*Skunk Creek Floodplain Delineation Study  
FCD 95-16*

## Technical Data Notebook

**SKUNK CREEK  
FLOODPLAIN DELINEATION STUDY**

**FCDMC CONTRACT 95-16**

**SUBJECT :** Skunk Creek Wash Topography and Floodplain Delineation, Contract No. 95-16  
(Subbasin delineation).

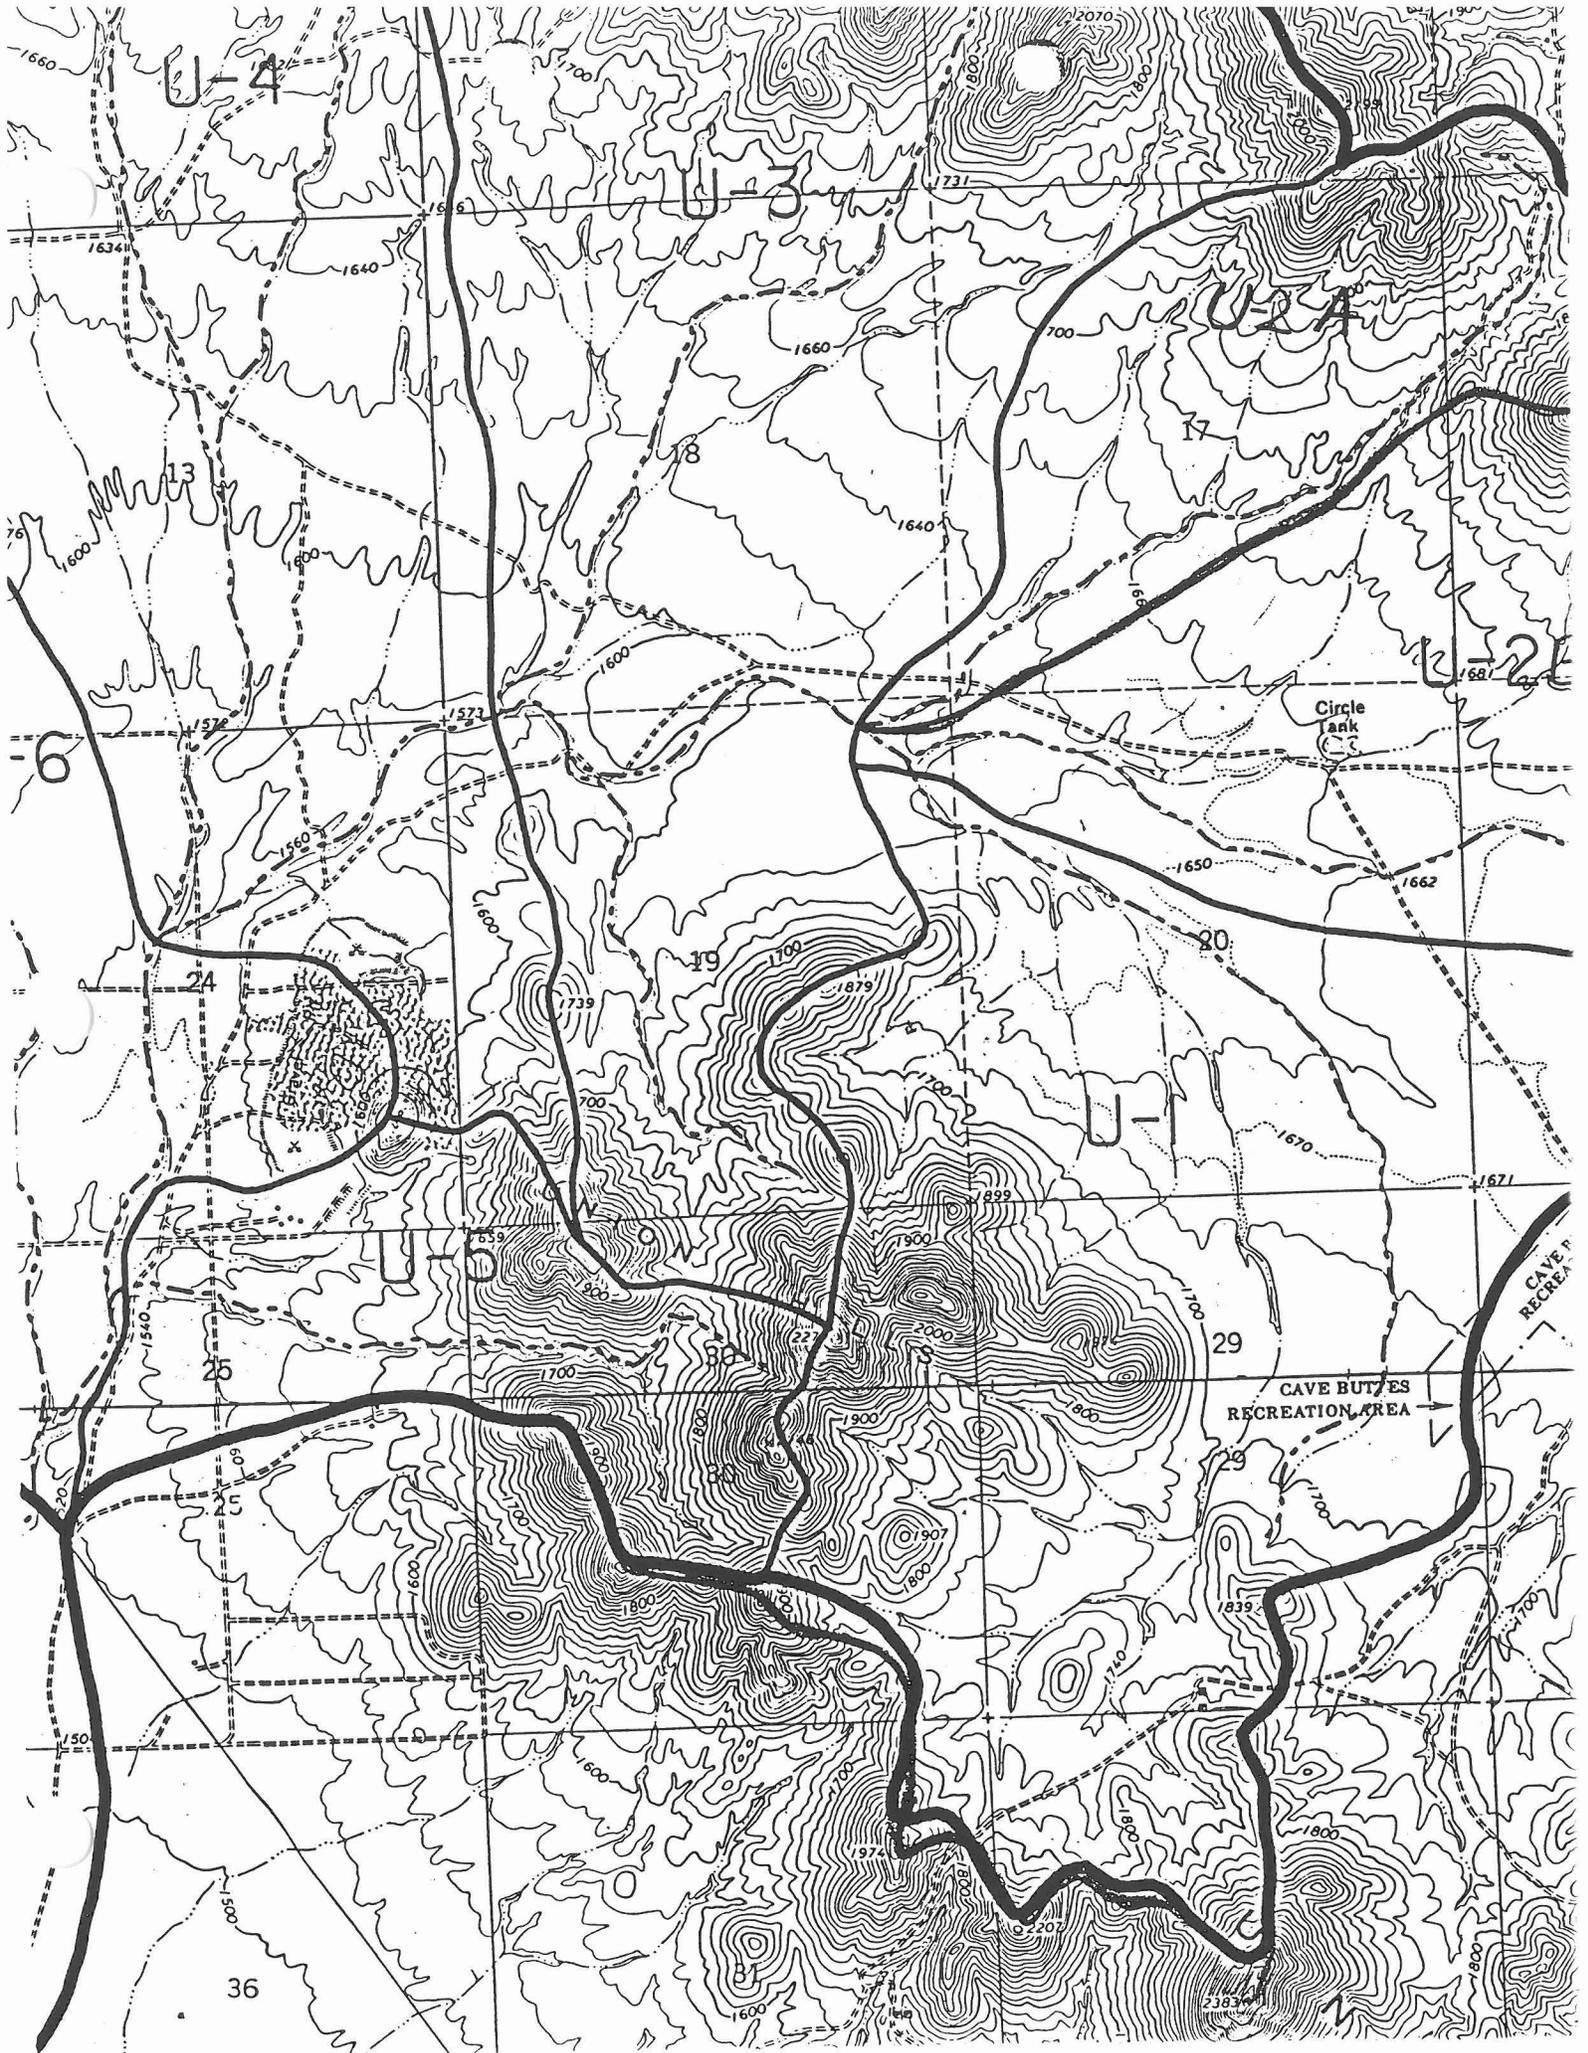
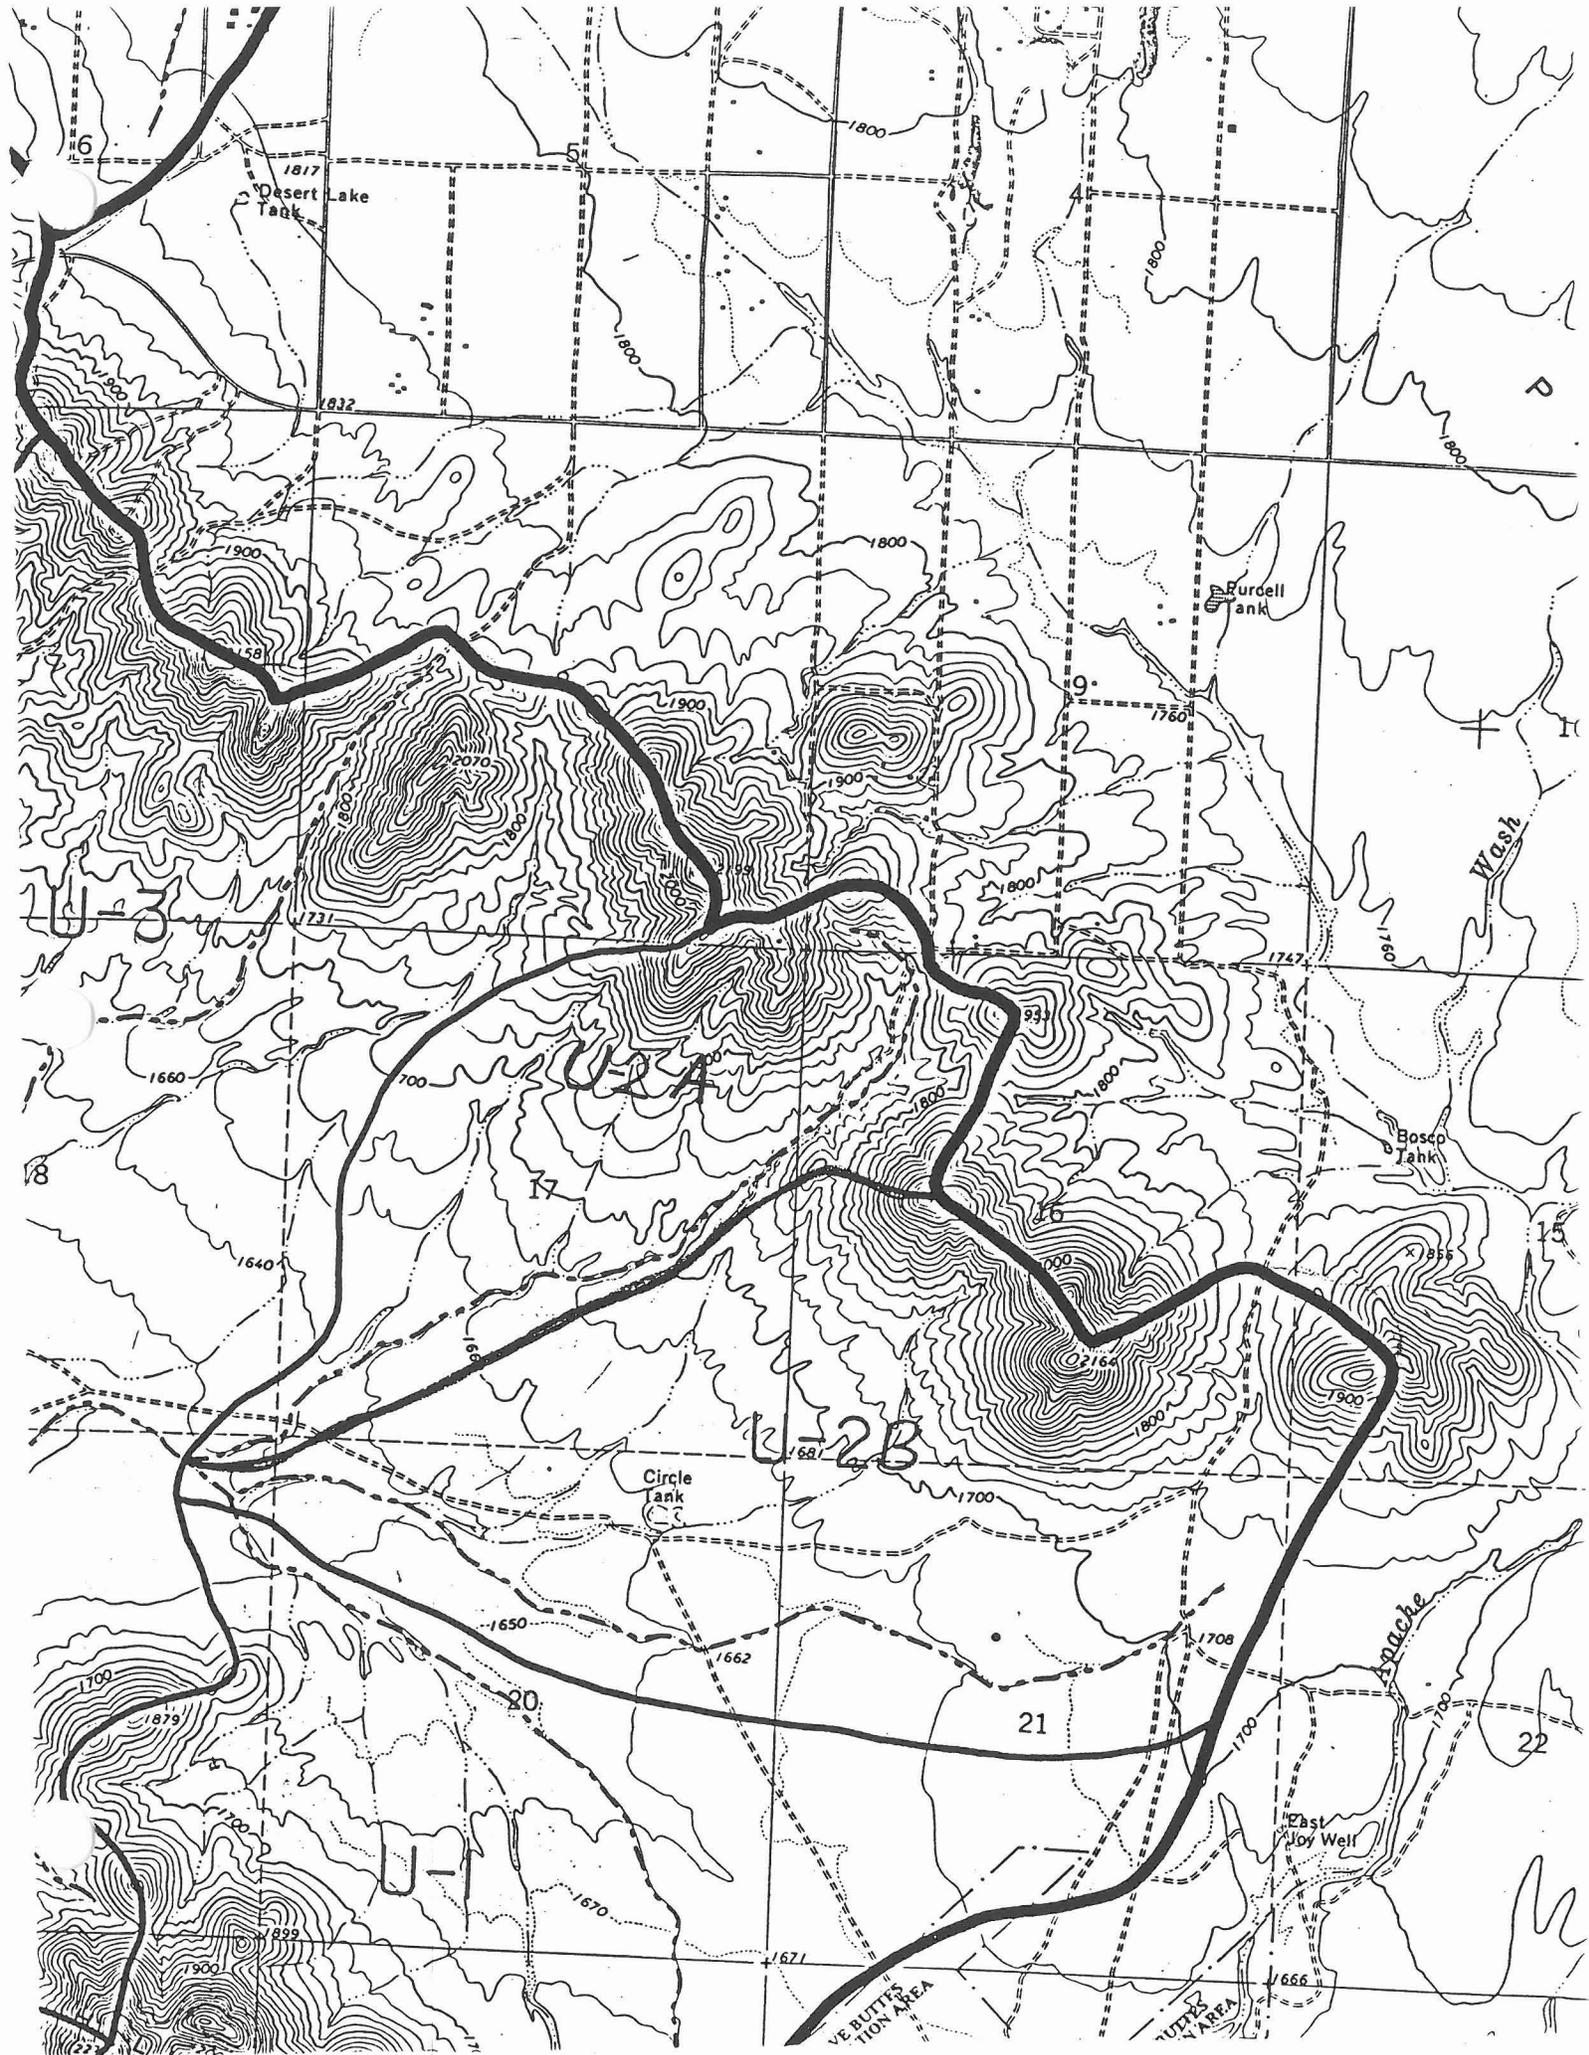
I have completed the review of the subbasin delineation. No significant errors were found. Following are the recommended modifications.

- (1) Please include a proper scale to the watershed subbasin map.
- (2) Subbasins S-2, S-10, S-13, and S-15 may have longer flow paths than shown on the current map (please see attached map).
- (3) It is also recommended that subbasins S-15, S-16, S-17, and U-2 be divided furthermore to create S-15A, S-15B, S-16A, S-16B, S-17A, S-17B, U-2A, and U-2B (please see attached map).
